The staff of Safety and Enforcement Division (SED) of the California Public Utilities Commission conducted a General Order (G.O) 112, Part 2 inspection of the Southern California Gas Company's and San Diego Gas and Electric Company's Gas Transmission Pipeline Integrity Management Program (TIMP) on March 2-6, March 9-13, and July 6-10, 2015. These two companies are collectively referred to as the Sempra Energy Utilities.

**Sempra 2015 TIMP Inspection Summary
March 2-6, March 9-13, and July 6-10, 2015**

Figure A: Illustration from Appendix E to Part 192

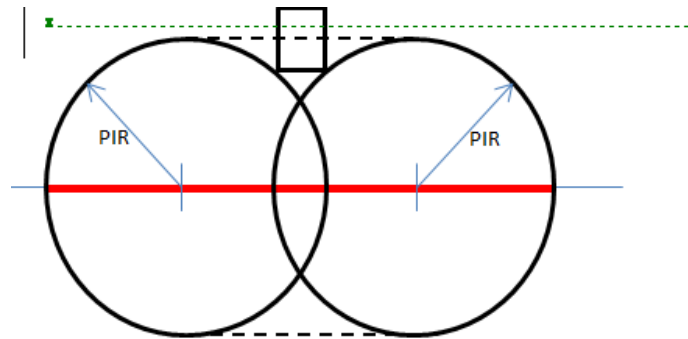
Sempra identified covered segments on Line 7000. One of the HCA segments (HCA # 1121816) on the Line 7000 was within an identified site and had a 90 degrees elbow turn and continued for a mile. However, this pipeline segment within the HCA # 1121816 did not extend completely to the outer edge of the potential impact circle that contains the identified site that contacts the outermost edge of the last contiguous potential impact circle. Piping locations were not appropriately identified as covered segments when the potential impact circle contained an identified site (using Method 2). Sempra did not provide a justification why it was not necessary to include the entire length of the pipeline

within the impact circle. Therefore, Sempra is in violation of 49 CFR, Part 192, §192.903(3).

The Sempra Energy Utilities employ an HCA identification method that meets the requirements of 49 CFR 192 regulations including §192.903 (3), this section of code references Figure E.1.A in Appendix E of Part 192 for determining extents of a HCA and is shown below in Figure A. As shown in the illustration, the length of the HCA extends axially outward from the centers of the first and last contiguous potential impact circle to the outermost edges of the impact circles; at a distance equal to the PIR. The Sempra Energy Utilities meet this requirement and measures the axial distance represented by PIR using pipeline length in feet.

Attached below is the aerial imagery of HCA 1121816 on Line 7000, which demonstrates the Sempra Energy Utilities' compliance. As the image shows, the corners of the identified site are touched by the outer edges of two potential impact circles with a radius of PIR. The PIR is calculated by the following equation as described in code:

$$PIR = r = 0.69 * \sqrt{(p*d^2)} = 295.82$$

Where pressure (p)= 718 , diameter (d)=16 , PIR= 295.82

The HCA was extended past the edge of the potential impact circle and the 90 degree angle by adding an addendum or safety factor to the PIR length. This is represented in Figure 1 as the end of the green highlight. The end of the green highlight is beyond the requirements of regulation and is based upon SoCal's use of an addendum.

As such, it is the Sempra Energy Utilities' belief that they have met the requirements of the 192.903 since the extent of the HCA is farther than the minimum requirement established by regulation. The Sempra Energy Utilities will look at enhancing its procedure to clarify its use of addendum when performing HCA identification. The Sempra Energy Utilities would also like to note that, as of June 3, 2013, the method in which HCA segments are determined for Line 7000 was changed from Method 2 to Method 1. Furthermore, Line 7000 was last assessed by in-line inspection on 10/4/2012, which is prior to the audit and in this area both HCA and non-HCA segments were assessed.
